**ADDENDUM #5**

**Will County Health Department**  
**BID PACKAGE #2 – Misc. Steel/Structural/Enclosure**  
**November 15, 2018**

**SECTION 00 91 07  
BP #2 - ADDENDUM NUMBER 5**

**PROJECT:**           **WILL COUNTY HEALTH DEPARTMENT - NEW HEALTH DEPARTMENT  
BUILDING  
501 ELLA AVENUE  
JOLIET, ILLINOIS 60433**

**S500**

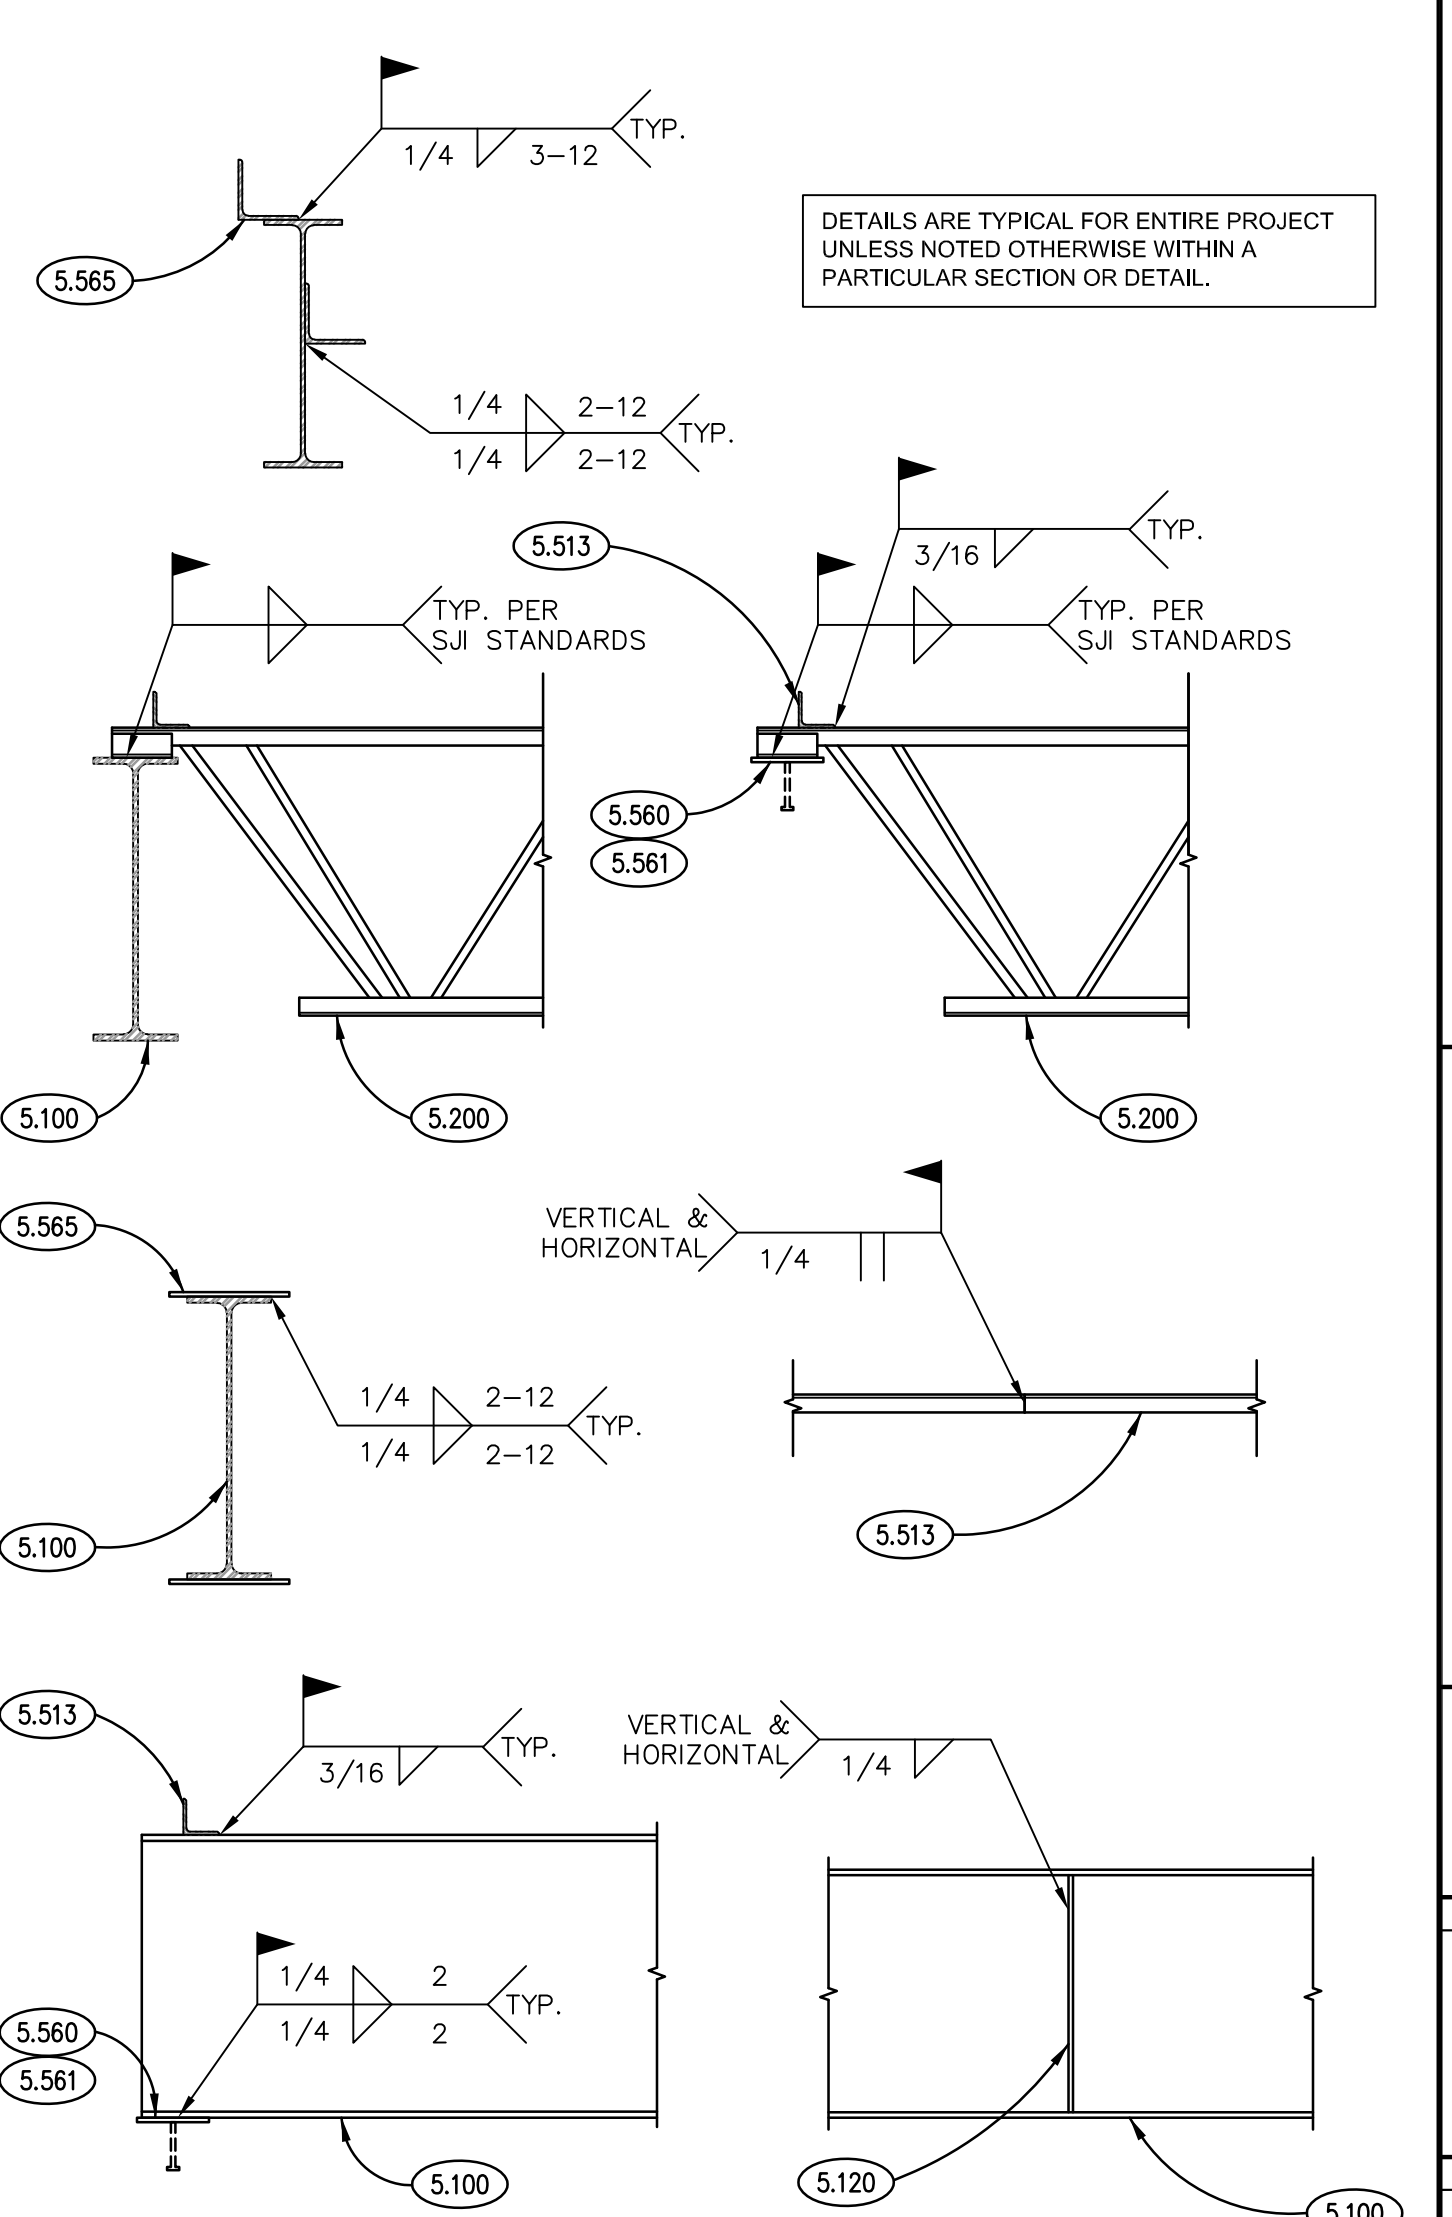
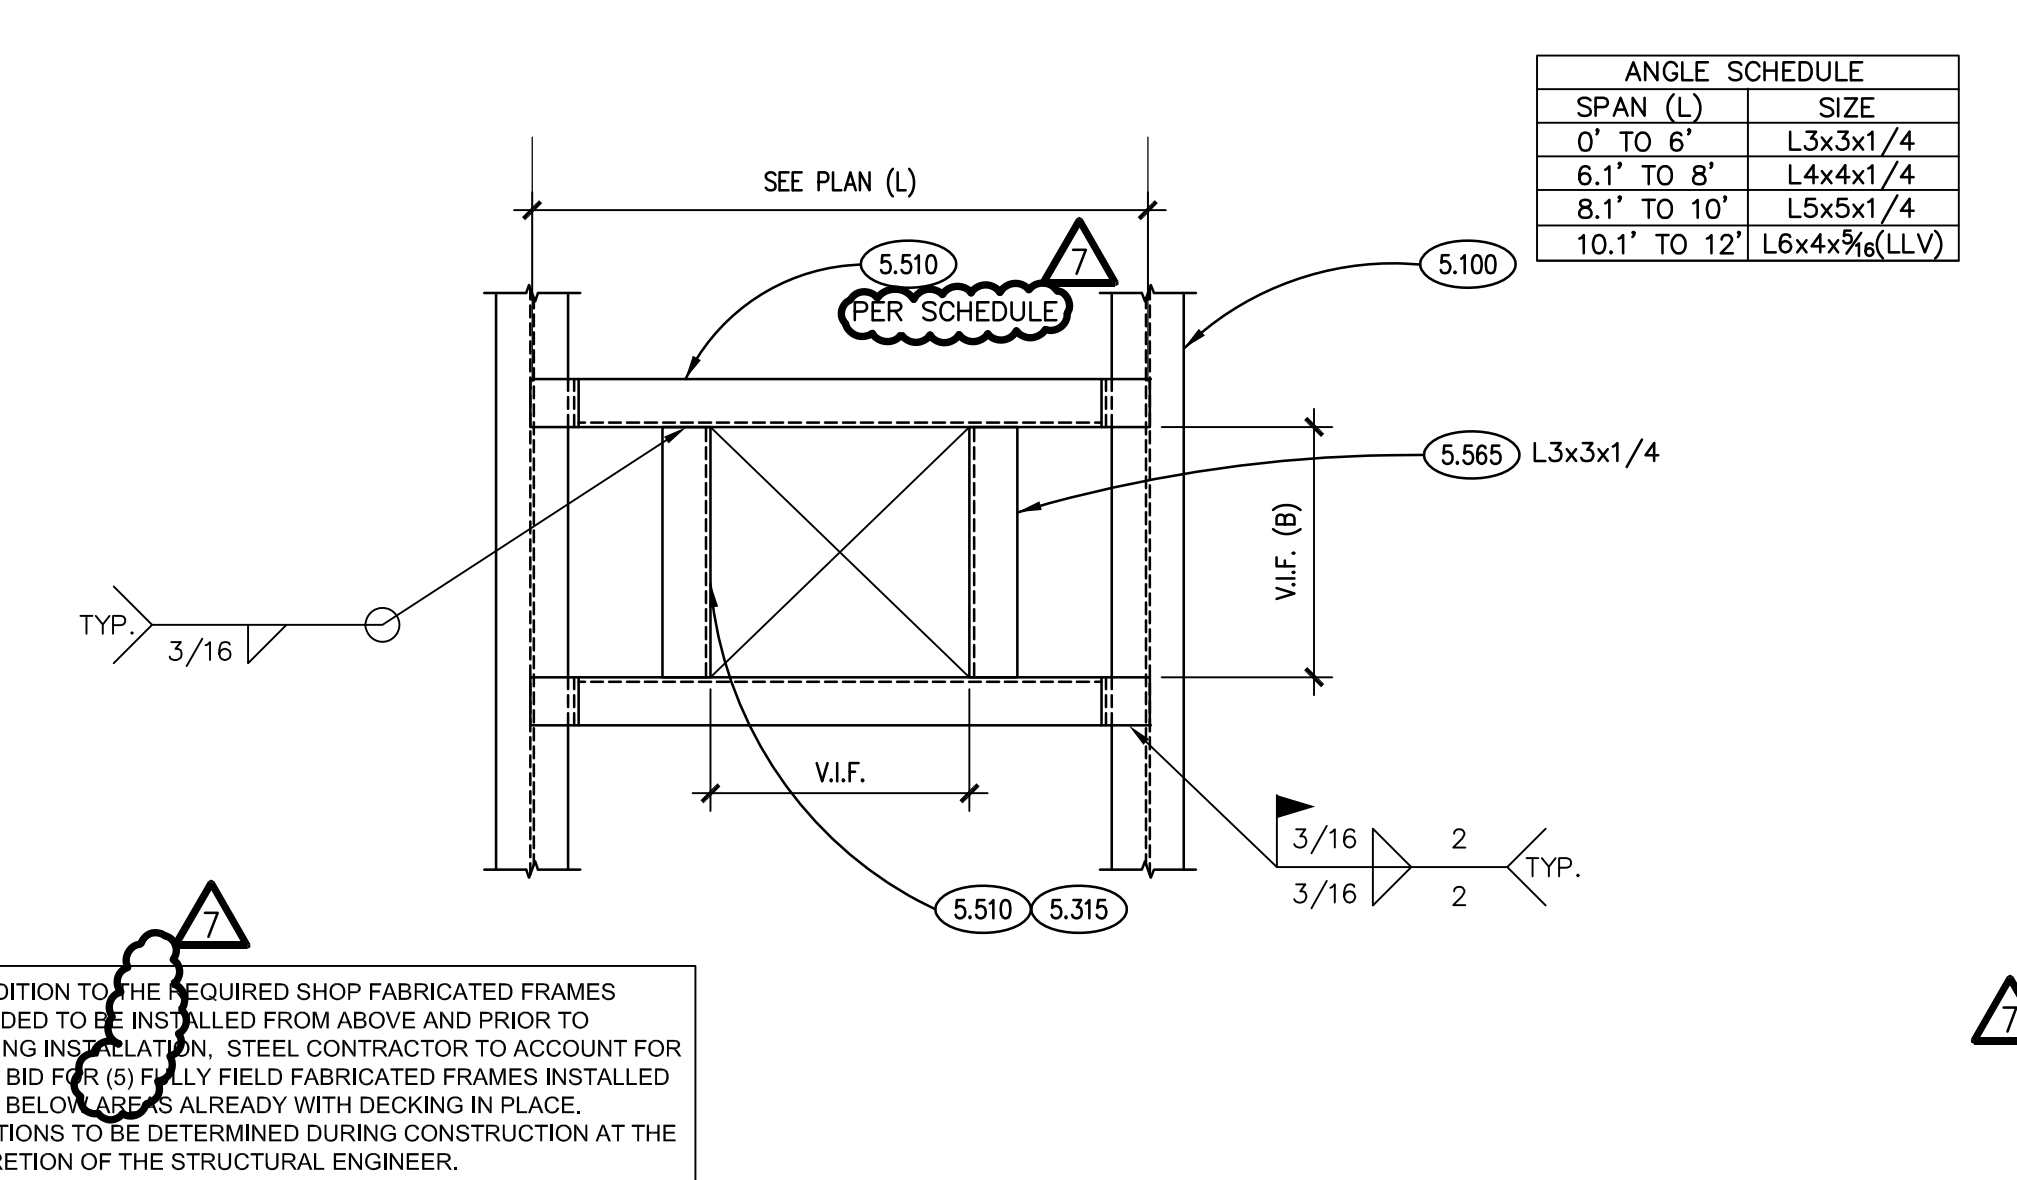
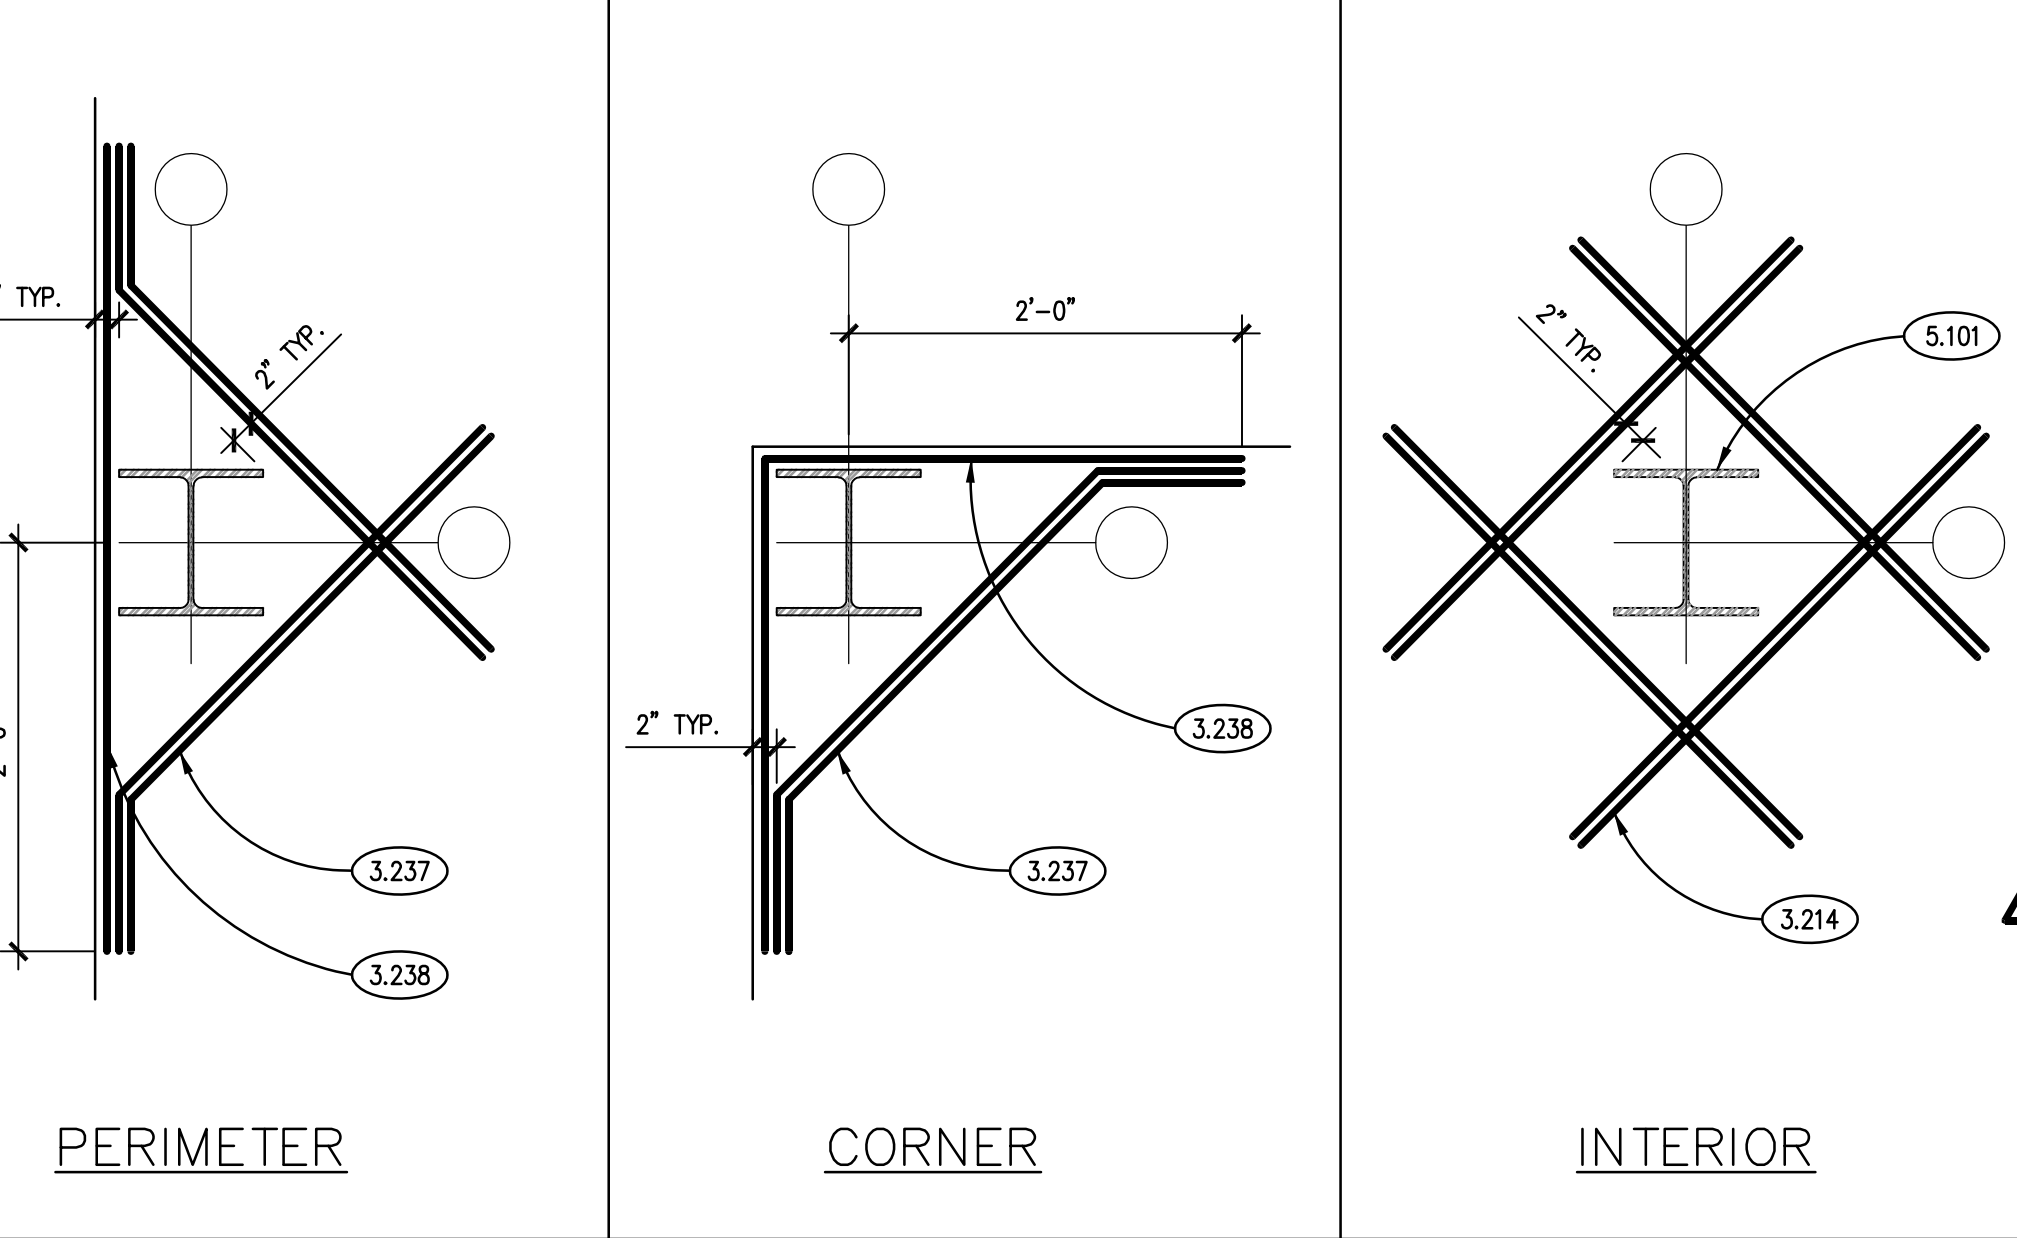
- A. Delete drawing in its entirety and replace with drawing number S500 (attached). Refer to revision cloud 9 for specific changes.
